PARK CITY MUNICIPAL CORPORATION  
HISTORIC PRESERVATION BOARD  
MINUTES OF MARCH 6, 2019

1. 227 Main Street – Historic District Design Review – Reconstruction and Material Deconstruction Review of a Significant Site. On August 1, 2018, the Historic Preservation Board approved the Reconstruction of the front (eastern) half of the building and associated Material Deconstruction. The applicant is now proposing to Reconstruct the rear (western) half to the building. The applicant is also proposing the Material Deconstruction of a portion of the west wall to accommodate a 64 square foot addition, windows and doors, and a non-historic addition.

# 227 Main Street (Star Hotel) Reconstruction & Material Deconstruction

# 540 Main Street Material Deconstruction Review

*Rear (west) Façade*

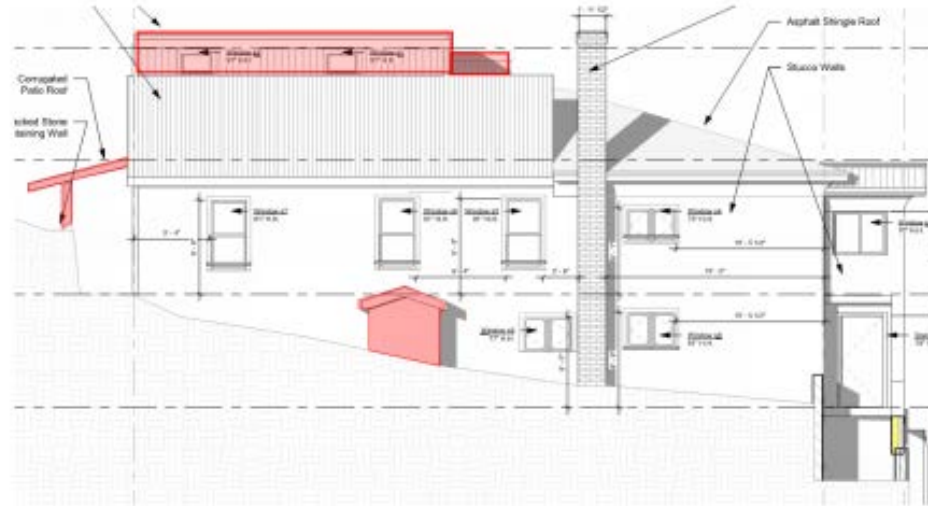
Planner Tyler reviewed the request for material deconstruction to help the Board understand exactly what needs to be removed in order to accommodate the reconstruction. Planner Tyler reviewed a photo of the current rear façade. The red area was the 1970s addition that would be removed. She showed another photo showing the restoration of the two gabled ends on the west side. She remarked that the Board needed to review the material deconstruction of the historic wall because they would be looking at removal of a portion of the wall to accommodate the 64 square foot addition. Director Erickson clarified that it was on the rear west façade, and it was below another house and not visible from the street.

Chair Stephens asked if the new addition was the area shown in gray. Planner Tyler answered yes. She noted that they were excavating the rear, but no material was being removed because it was the existing structure.

**Side (south) Façade**

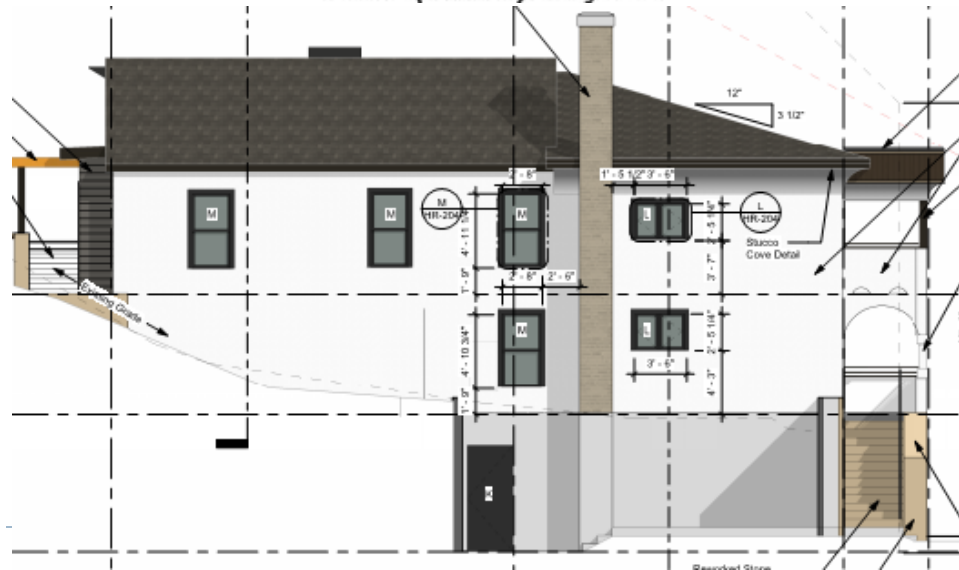
Planner Tyler indicated a photo showing the current conditions. The red area on the top of the ridge was the rear 1970s addition. Another photo showed the restorations of the structure in whole to match the cross-canyon view.

**Side (north) Façade**

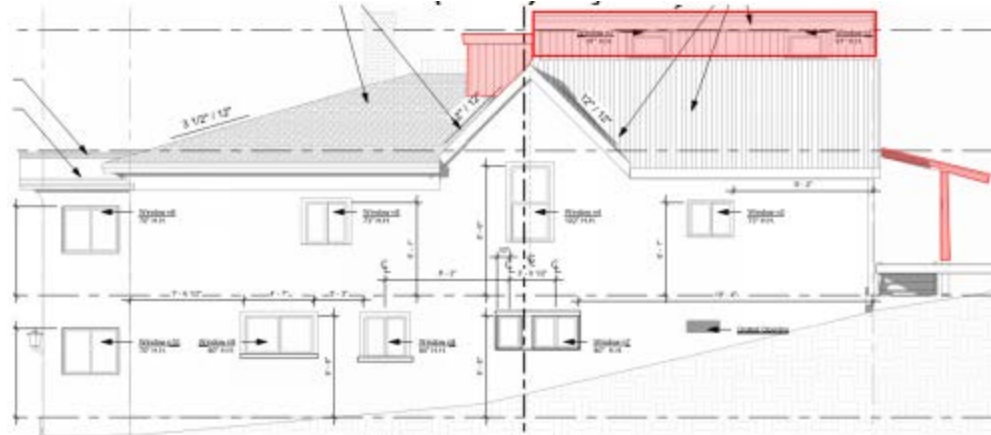
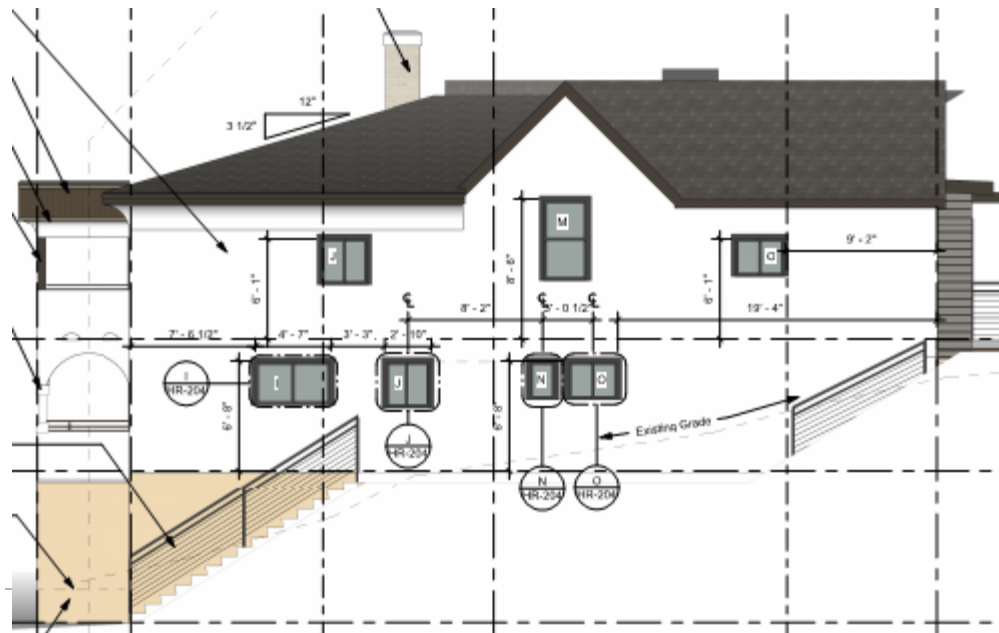
Board Member Hodgkins asked when the north gable was added. He understood that the applicant was proposing to keep the north gable. Planner Tyler replied that that portion would be restored in whole. She stated that the purpose of that section in the Staff report was to explain the center island area. There was no proof of what the roof shape was at one time. The Staff finds that restoring the two gable forms tells the actual story of the 1889 cross-wing cottage by having the flat roof in the back. The Staff thought it is an adequate interpretation based on the lack of evidence showing how it was historically.

**Front (east) Façade**

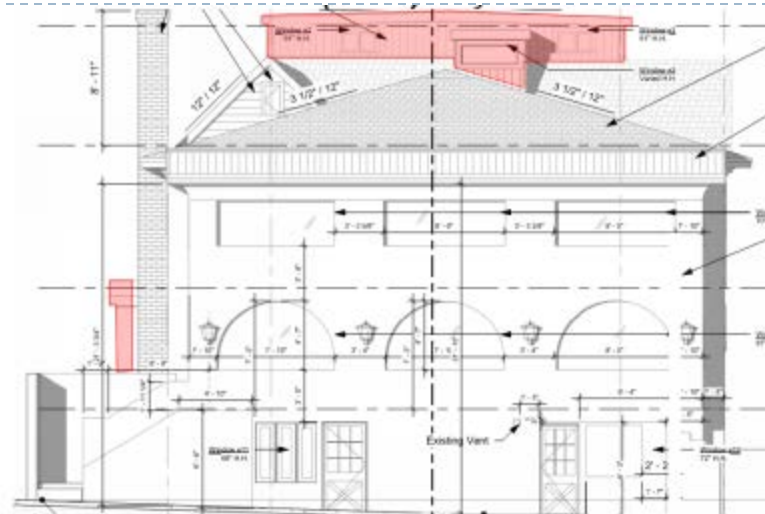
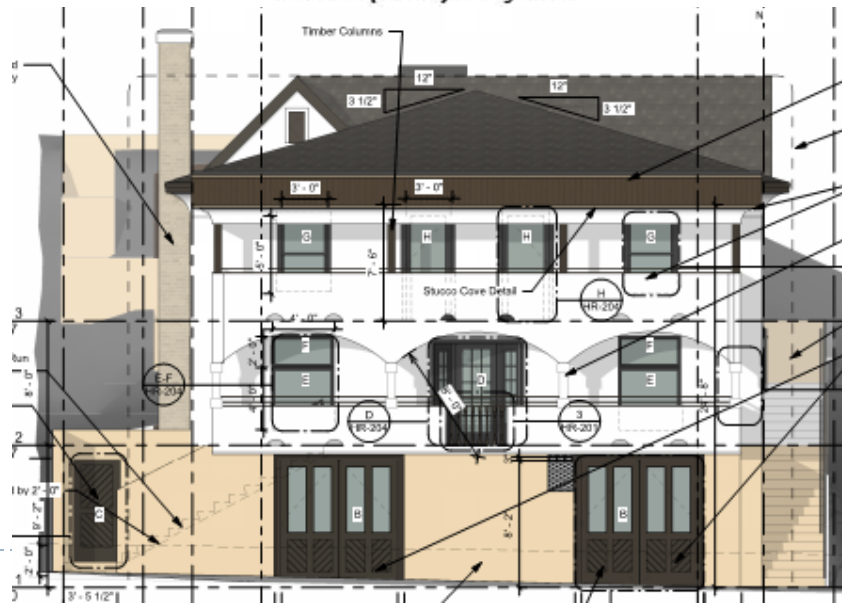
Planner Tyler reviewed the front façade. She stated that everything on top from the 1970s would be removed to return to the cross-wing cottage that was added to in the 1920s.

Commissioner Beatlebrox noted that the gable on the right-hand side was not shown in one of the photos. Planner Tyler referred to a photo in the Staff report showing that the roof line matches what was there historically. Director Erickson stated that the gables were progressive over time. Ms. Beatlebrox asked if it was necessary to have the gable on the left-hand side. Planner Tyler stated that through the Sanborn maps they have proven what the footprint of this building was originally. She pointed to the roof lines of the cross-wing cottage, and what was added on over time.

**East Elevation (Swede Alley façade)**

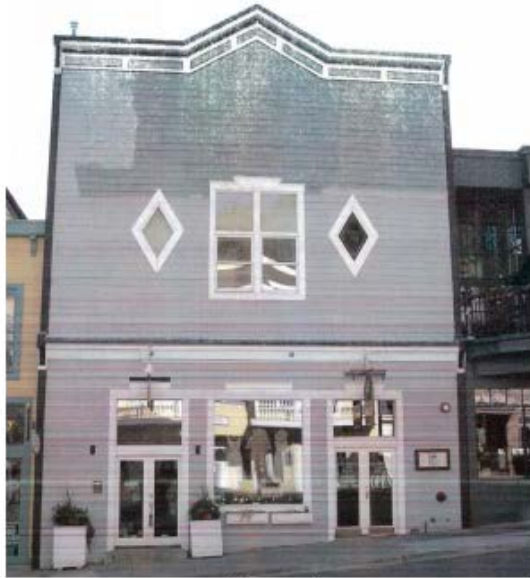
Planner Tyler stated that the rear façade was the portion of the structure being discussed this evening. She presented a photo showing what it looks like today. The addition shown in yellow was an addition that extends to Main Street. That addition was approved through the HDDR process in the 1990s. She indicated a window that she understood was part of that addition. Planner Tyler believed the historic photo was from the 1930s. She pointed to three windows and a door in the historic photo that still exist today. The addition was added on to the corner of the building and there was a window above it.

Planner Tyler highlighted some of the higher level guidelines. Since it was obvious that the façade has already been altered, the point might be made that one additional window may or may not have an effect. Planner Tyler pointed to a photograph which represented four openings on the façade that could still be read today because that lower window is not added. The Staff was concerned that once the window is added, they might lose the ability to read the integrity of the rear facade.

Mr. DeGray pointed out that this applicant was only requesting a window. He did not believe that removal of the wall material to accommodate the window would diminish the historic integrity of the building to such an extent that it would no longer be seen as a historic structure. He thought it would add to the usability of the building for the tenant and for the owner. It would also encourage pedestrian and commercial use on Swede Alley.

Board Member Hodgkins believed the doorway and 80% of a window were the only historic elements left. He did not think an additional window would compromise the historic integrity.

Board Member Hodgkins asked if it was certain that historic material would be removed to accommodate the window. Planner Tyler replied that the physical conditions report does not specify whether or not there is historic material. Mr. DeGray stated that the applicant had done the Tenant Improvement for the retail space. That went into the walls a little, but not enough to be able to tell for sure about the materials. Mr. DeGray remarked that the floor structures have been completely renovated with a web joist material. There is no historic material. Mr. Hodgkins asked if it would still come before the HPB if the material is non-

MOTION: Board Member Beatlebrox moved to APPROVE the material deconstruction of a portion of the Swede Alley façade of the Landmark Structure located at 540 Main Street, and to direct the Staff to prepare Findings of Fact, Conclusions of Law, and Conditions of Approval for final action. Board Member Holmgren seconded the motion.
